Playground Safety Inspection

Inspected by: William (Bill) Jenks, CPSI #30229-0318

Inspection Date: 19 February 2022

Site Name: Princeton Park Trails II
Address: 1615 Blackburn Way

Geotextile fabric exposed

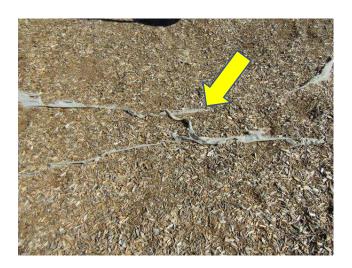
Large strips of geotextile fabric is exposed in several locations creating trip hazards.

>Fabric needs to be repositioned under the EWF (Engineered Wood Fiber).

Fabric exposed

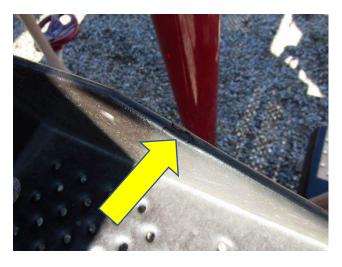
Sidewalk wood spacer is pulled away from the ground creating a trip hazard next to middle Shade Bench.

Fabric exposed

Sidewalk spacer creating trip hazard

Tightened all loose hardware

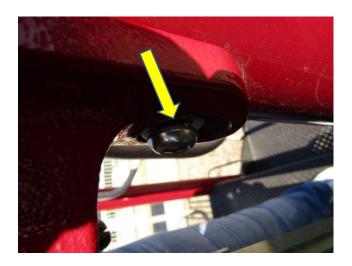
Very MINOR PVC damage on transfer station steps. Continue to monitor. Tightened 90% of all hardware throughout entire play structure during inspection.

MINOR PVC damage transfer station steps
